KAISER STEEL CORPORATION  
SUNNYSIDE COAL MINES  
SUNNYSIDE, UTAH 84539  
TELEPHONE 801-888-4421

RE: Plans for NOV N85-4-4-2, #1

Re: Review of Abatement Plan for NOV N85-4-17-3, 2 Of 3, Sunnyside Mines, Kaiser Coal Corporation, ACT/007/007, Carbon County, Utah

RE: NOV N85-4-17-3 Part 2 of 3  
Sunnyside Mines, ACT/007/007

Codrese Refuse Toe  
Failure Zone

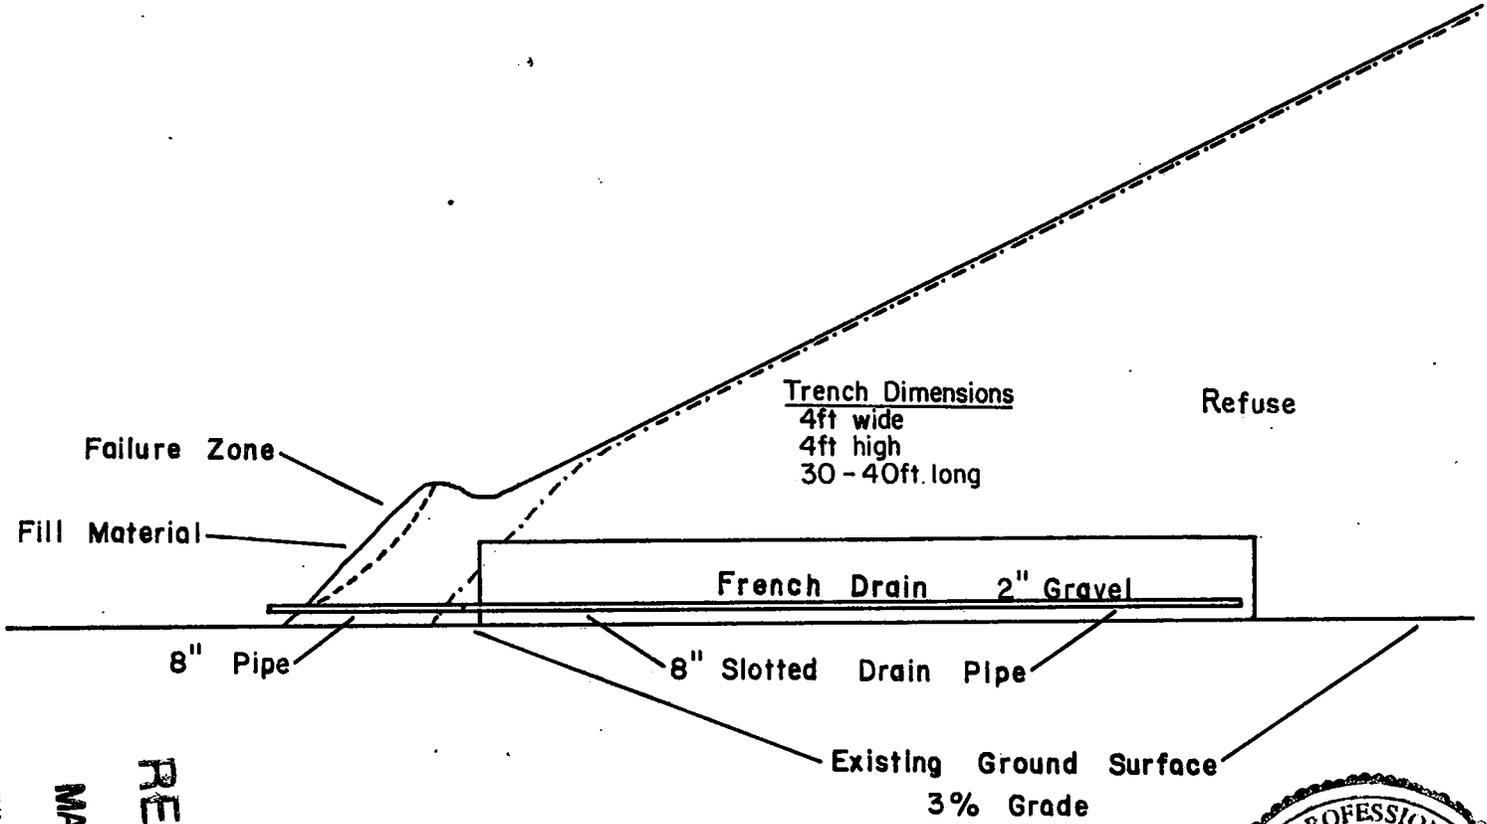
2. "the French drain proposal"

See the attached letter from Daniel R. Hadley.

3. "if the french drains don't work, what else could be done?"

Drainage pipes could be driven into the pile forming a drain. This is not a preferable alternative because of saturated ground conditions at the base of the wash.

Trench Dimensions  
4ft wide  
4ft high  
30 - 40ft. long
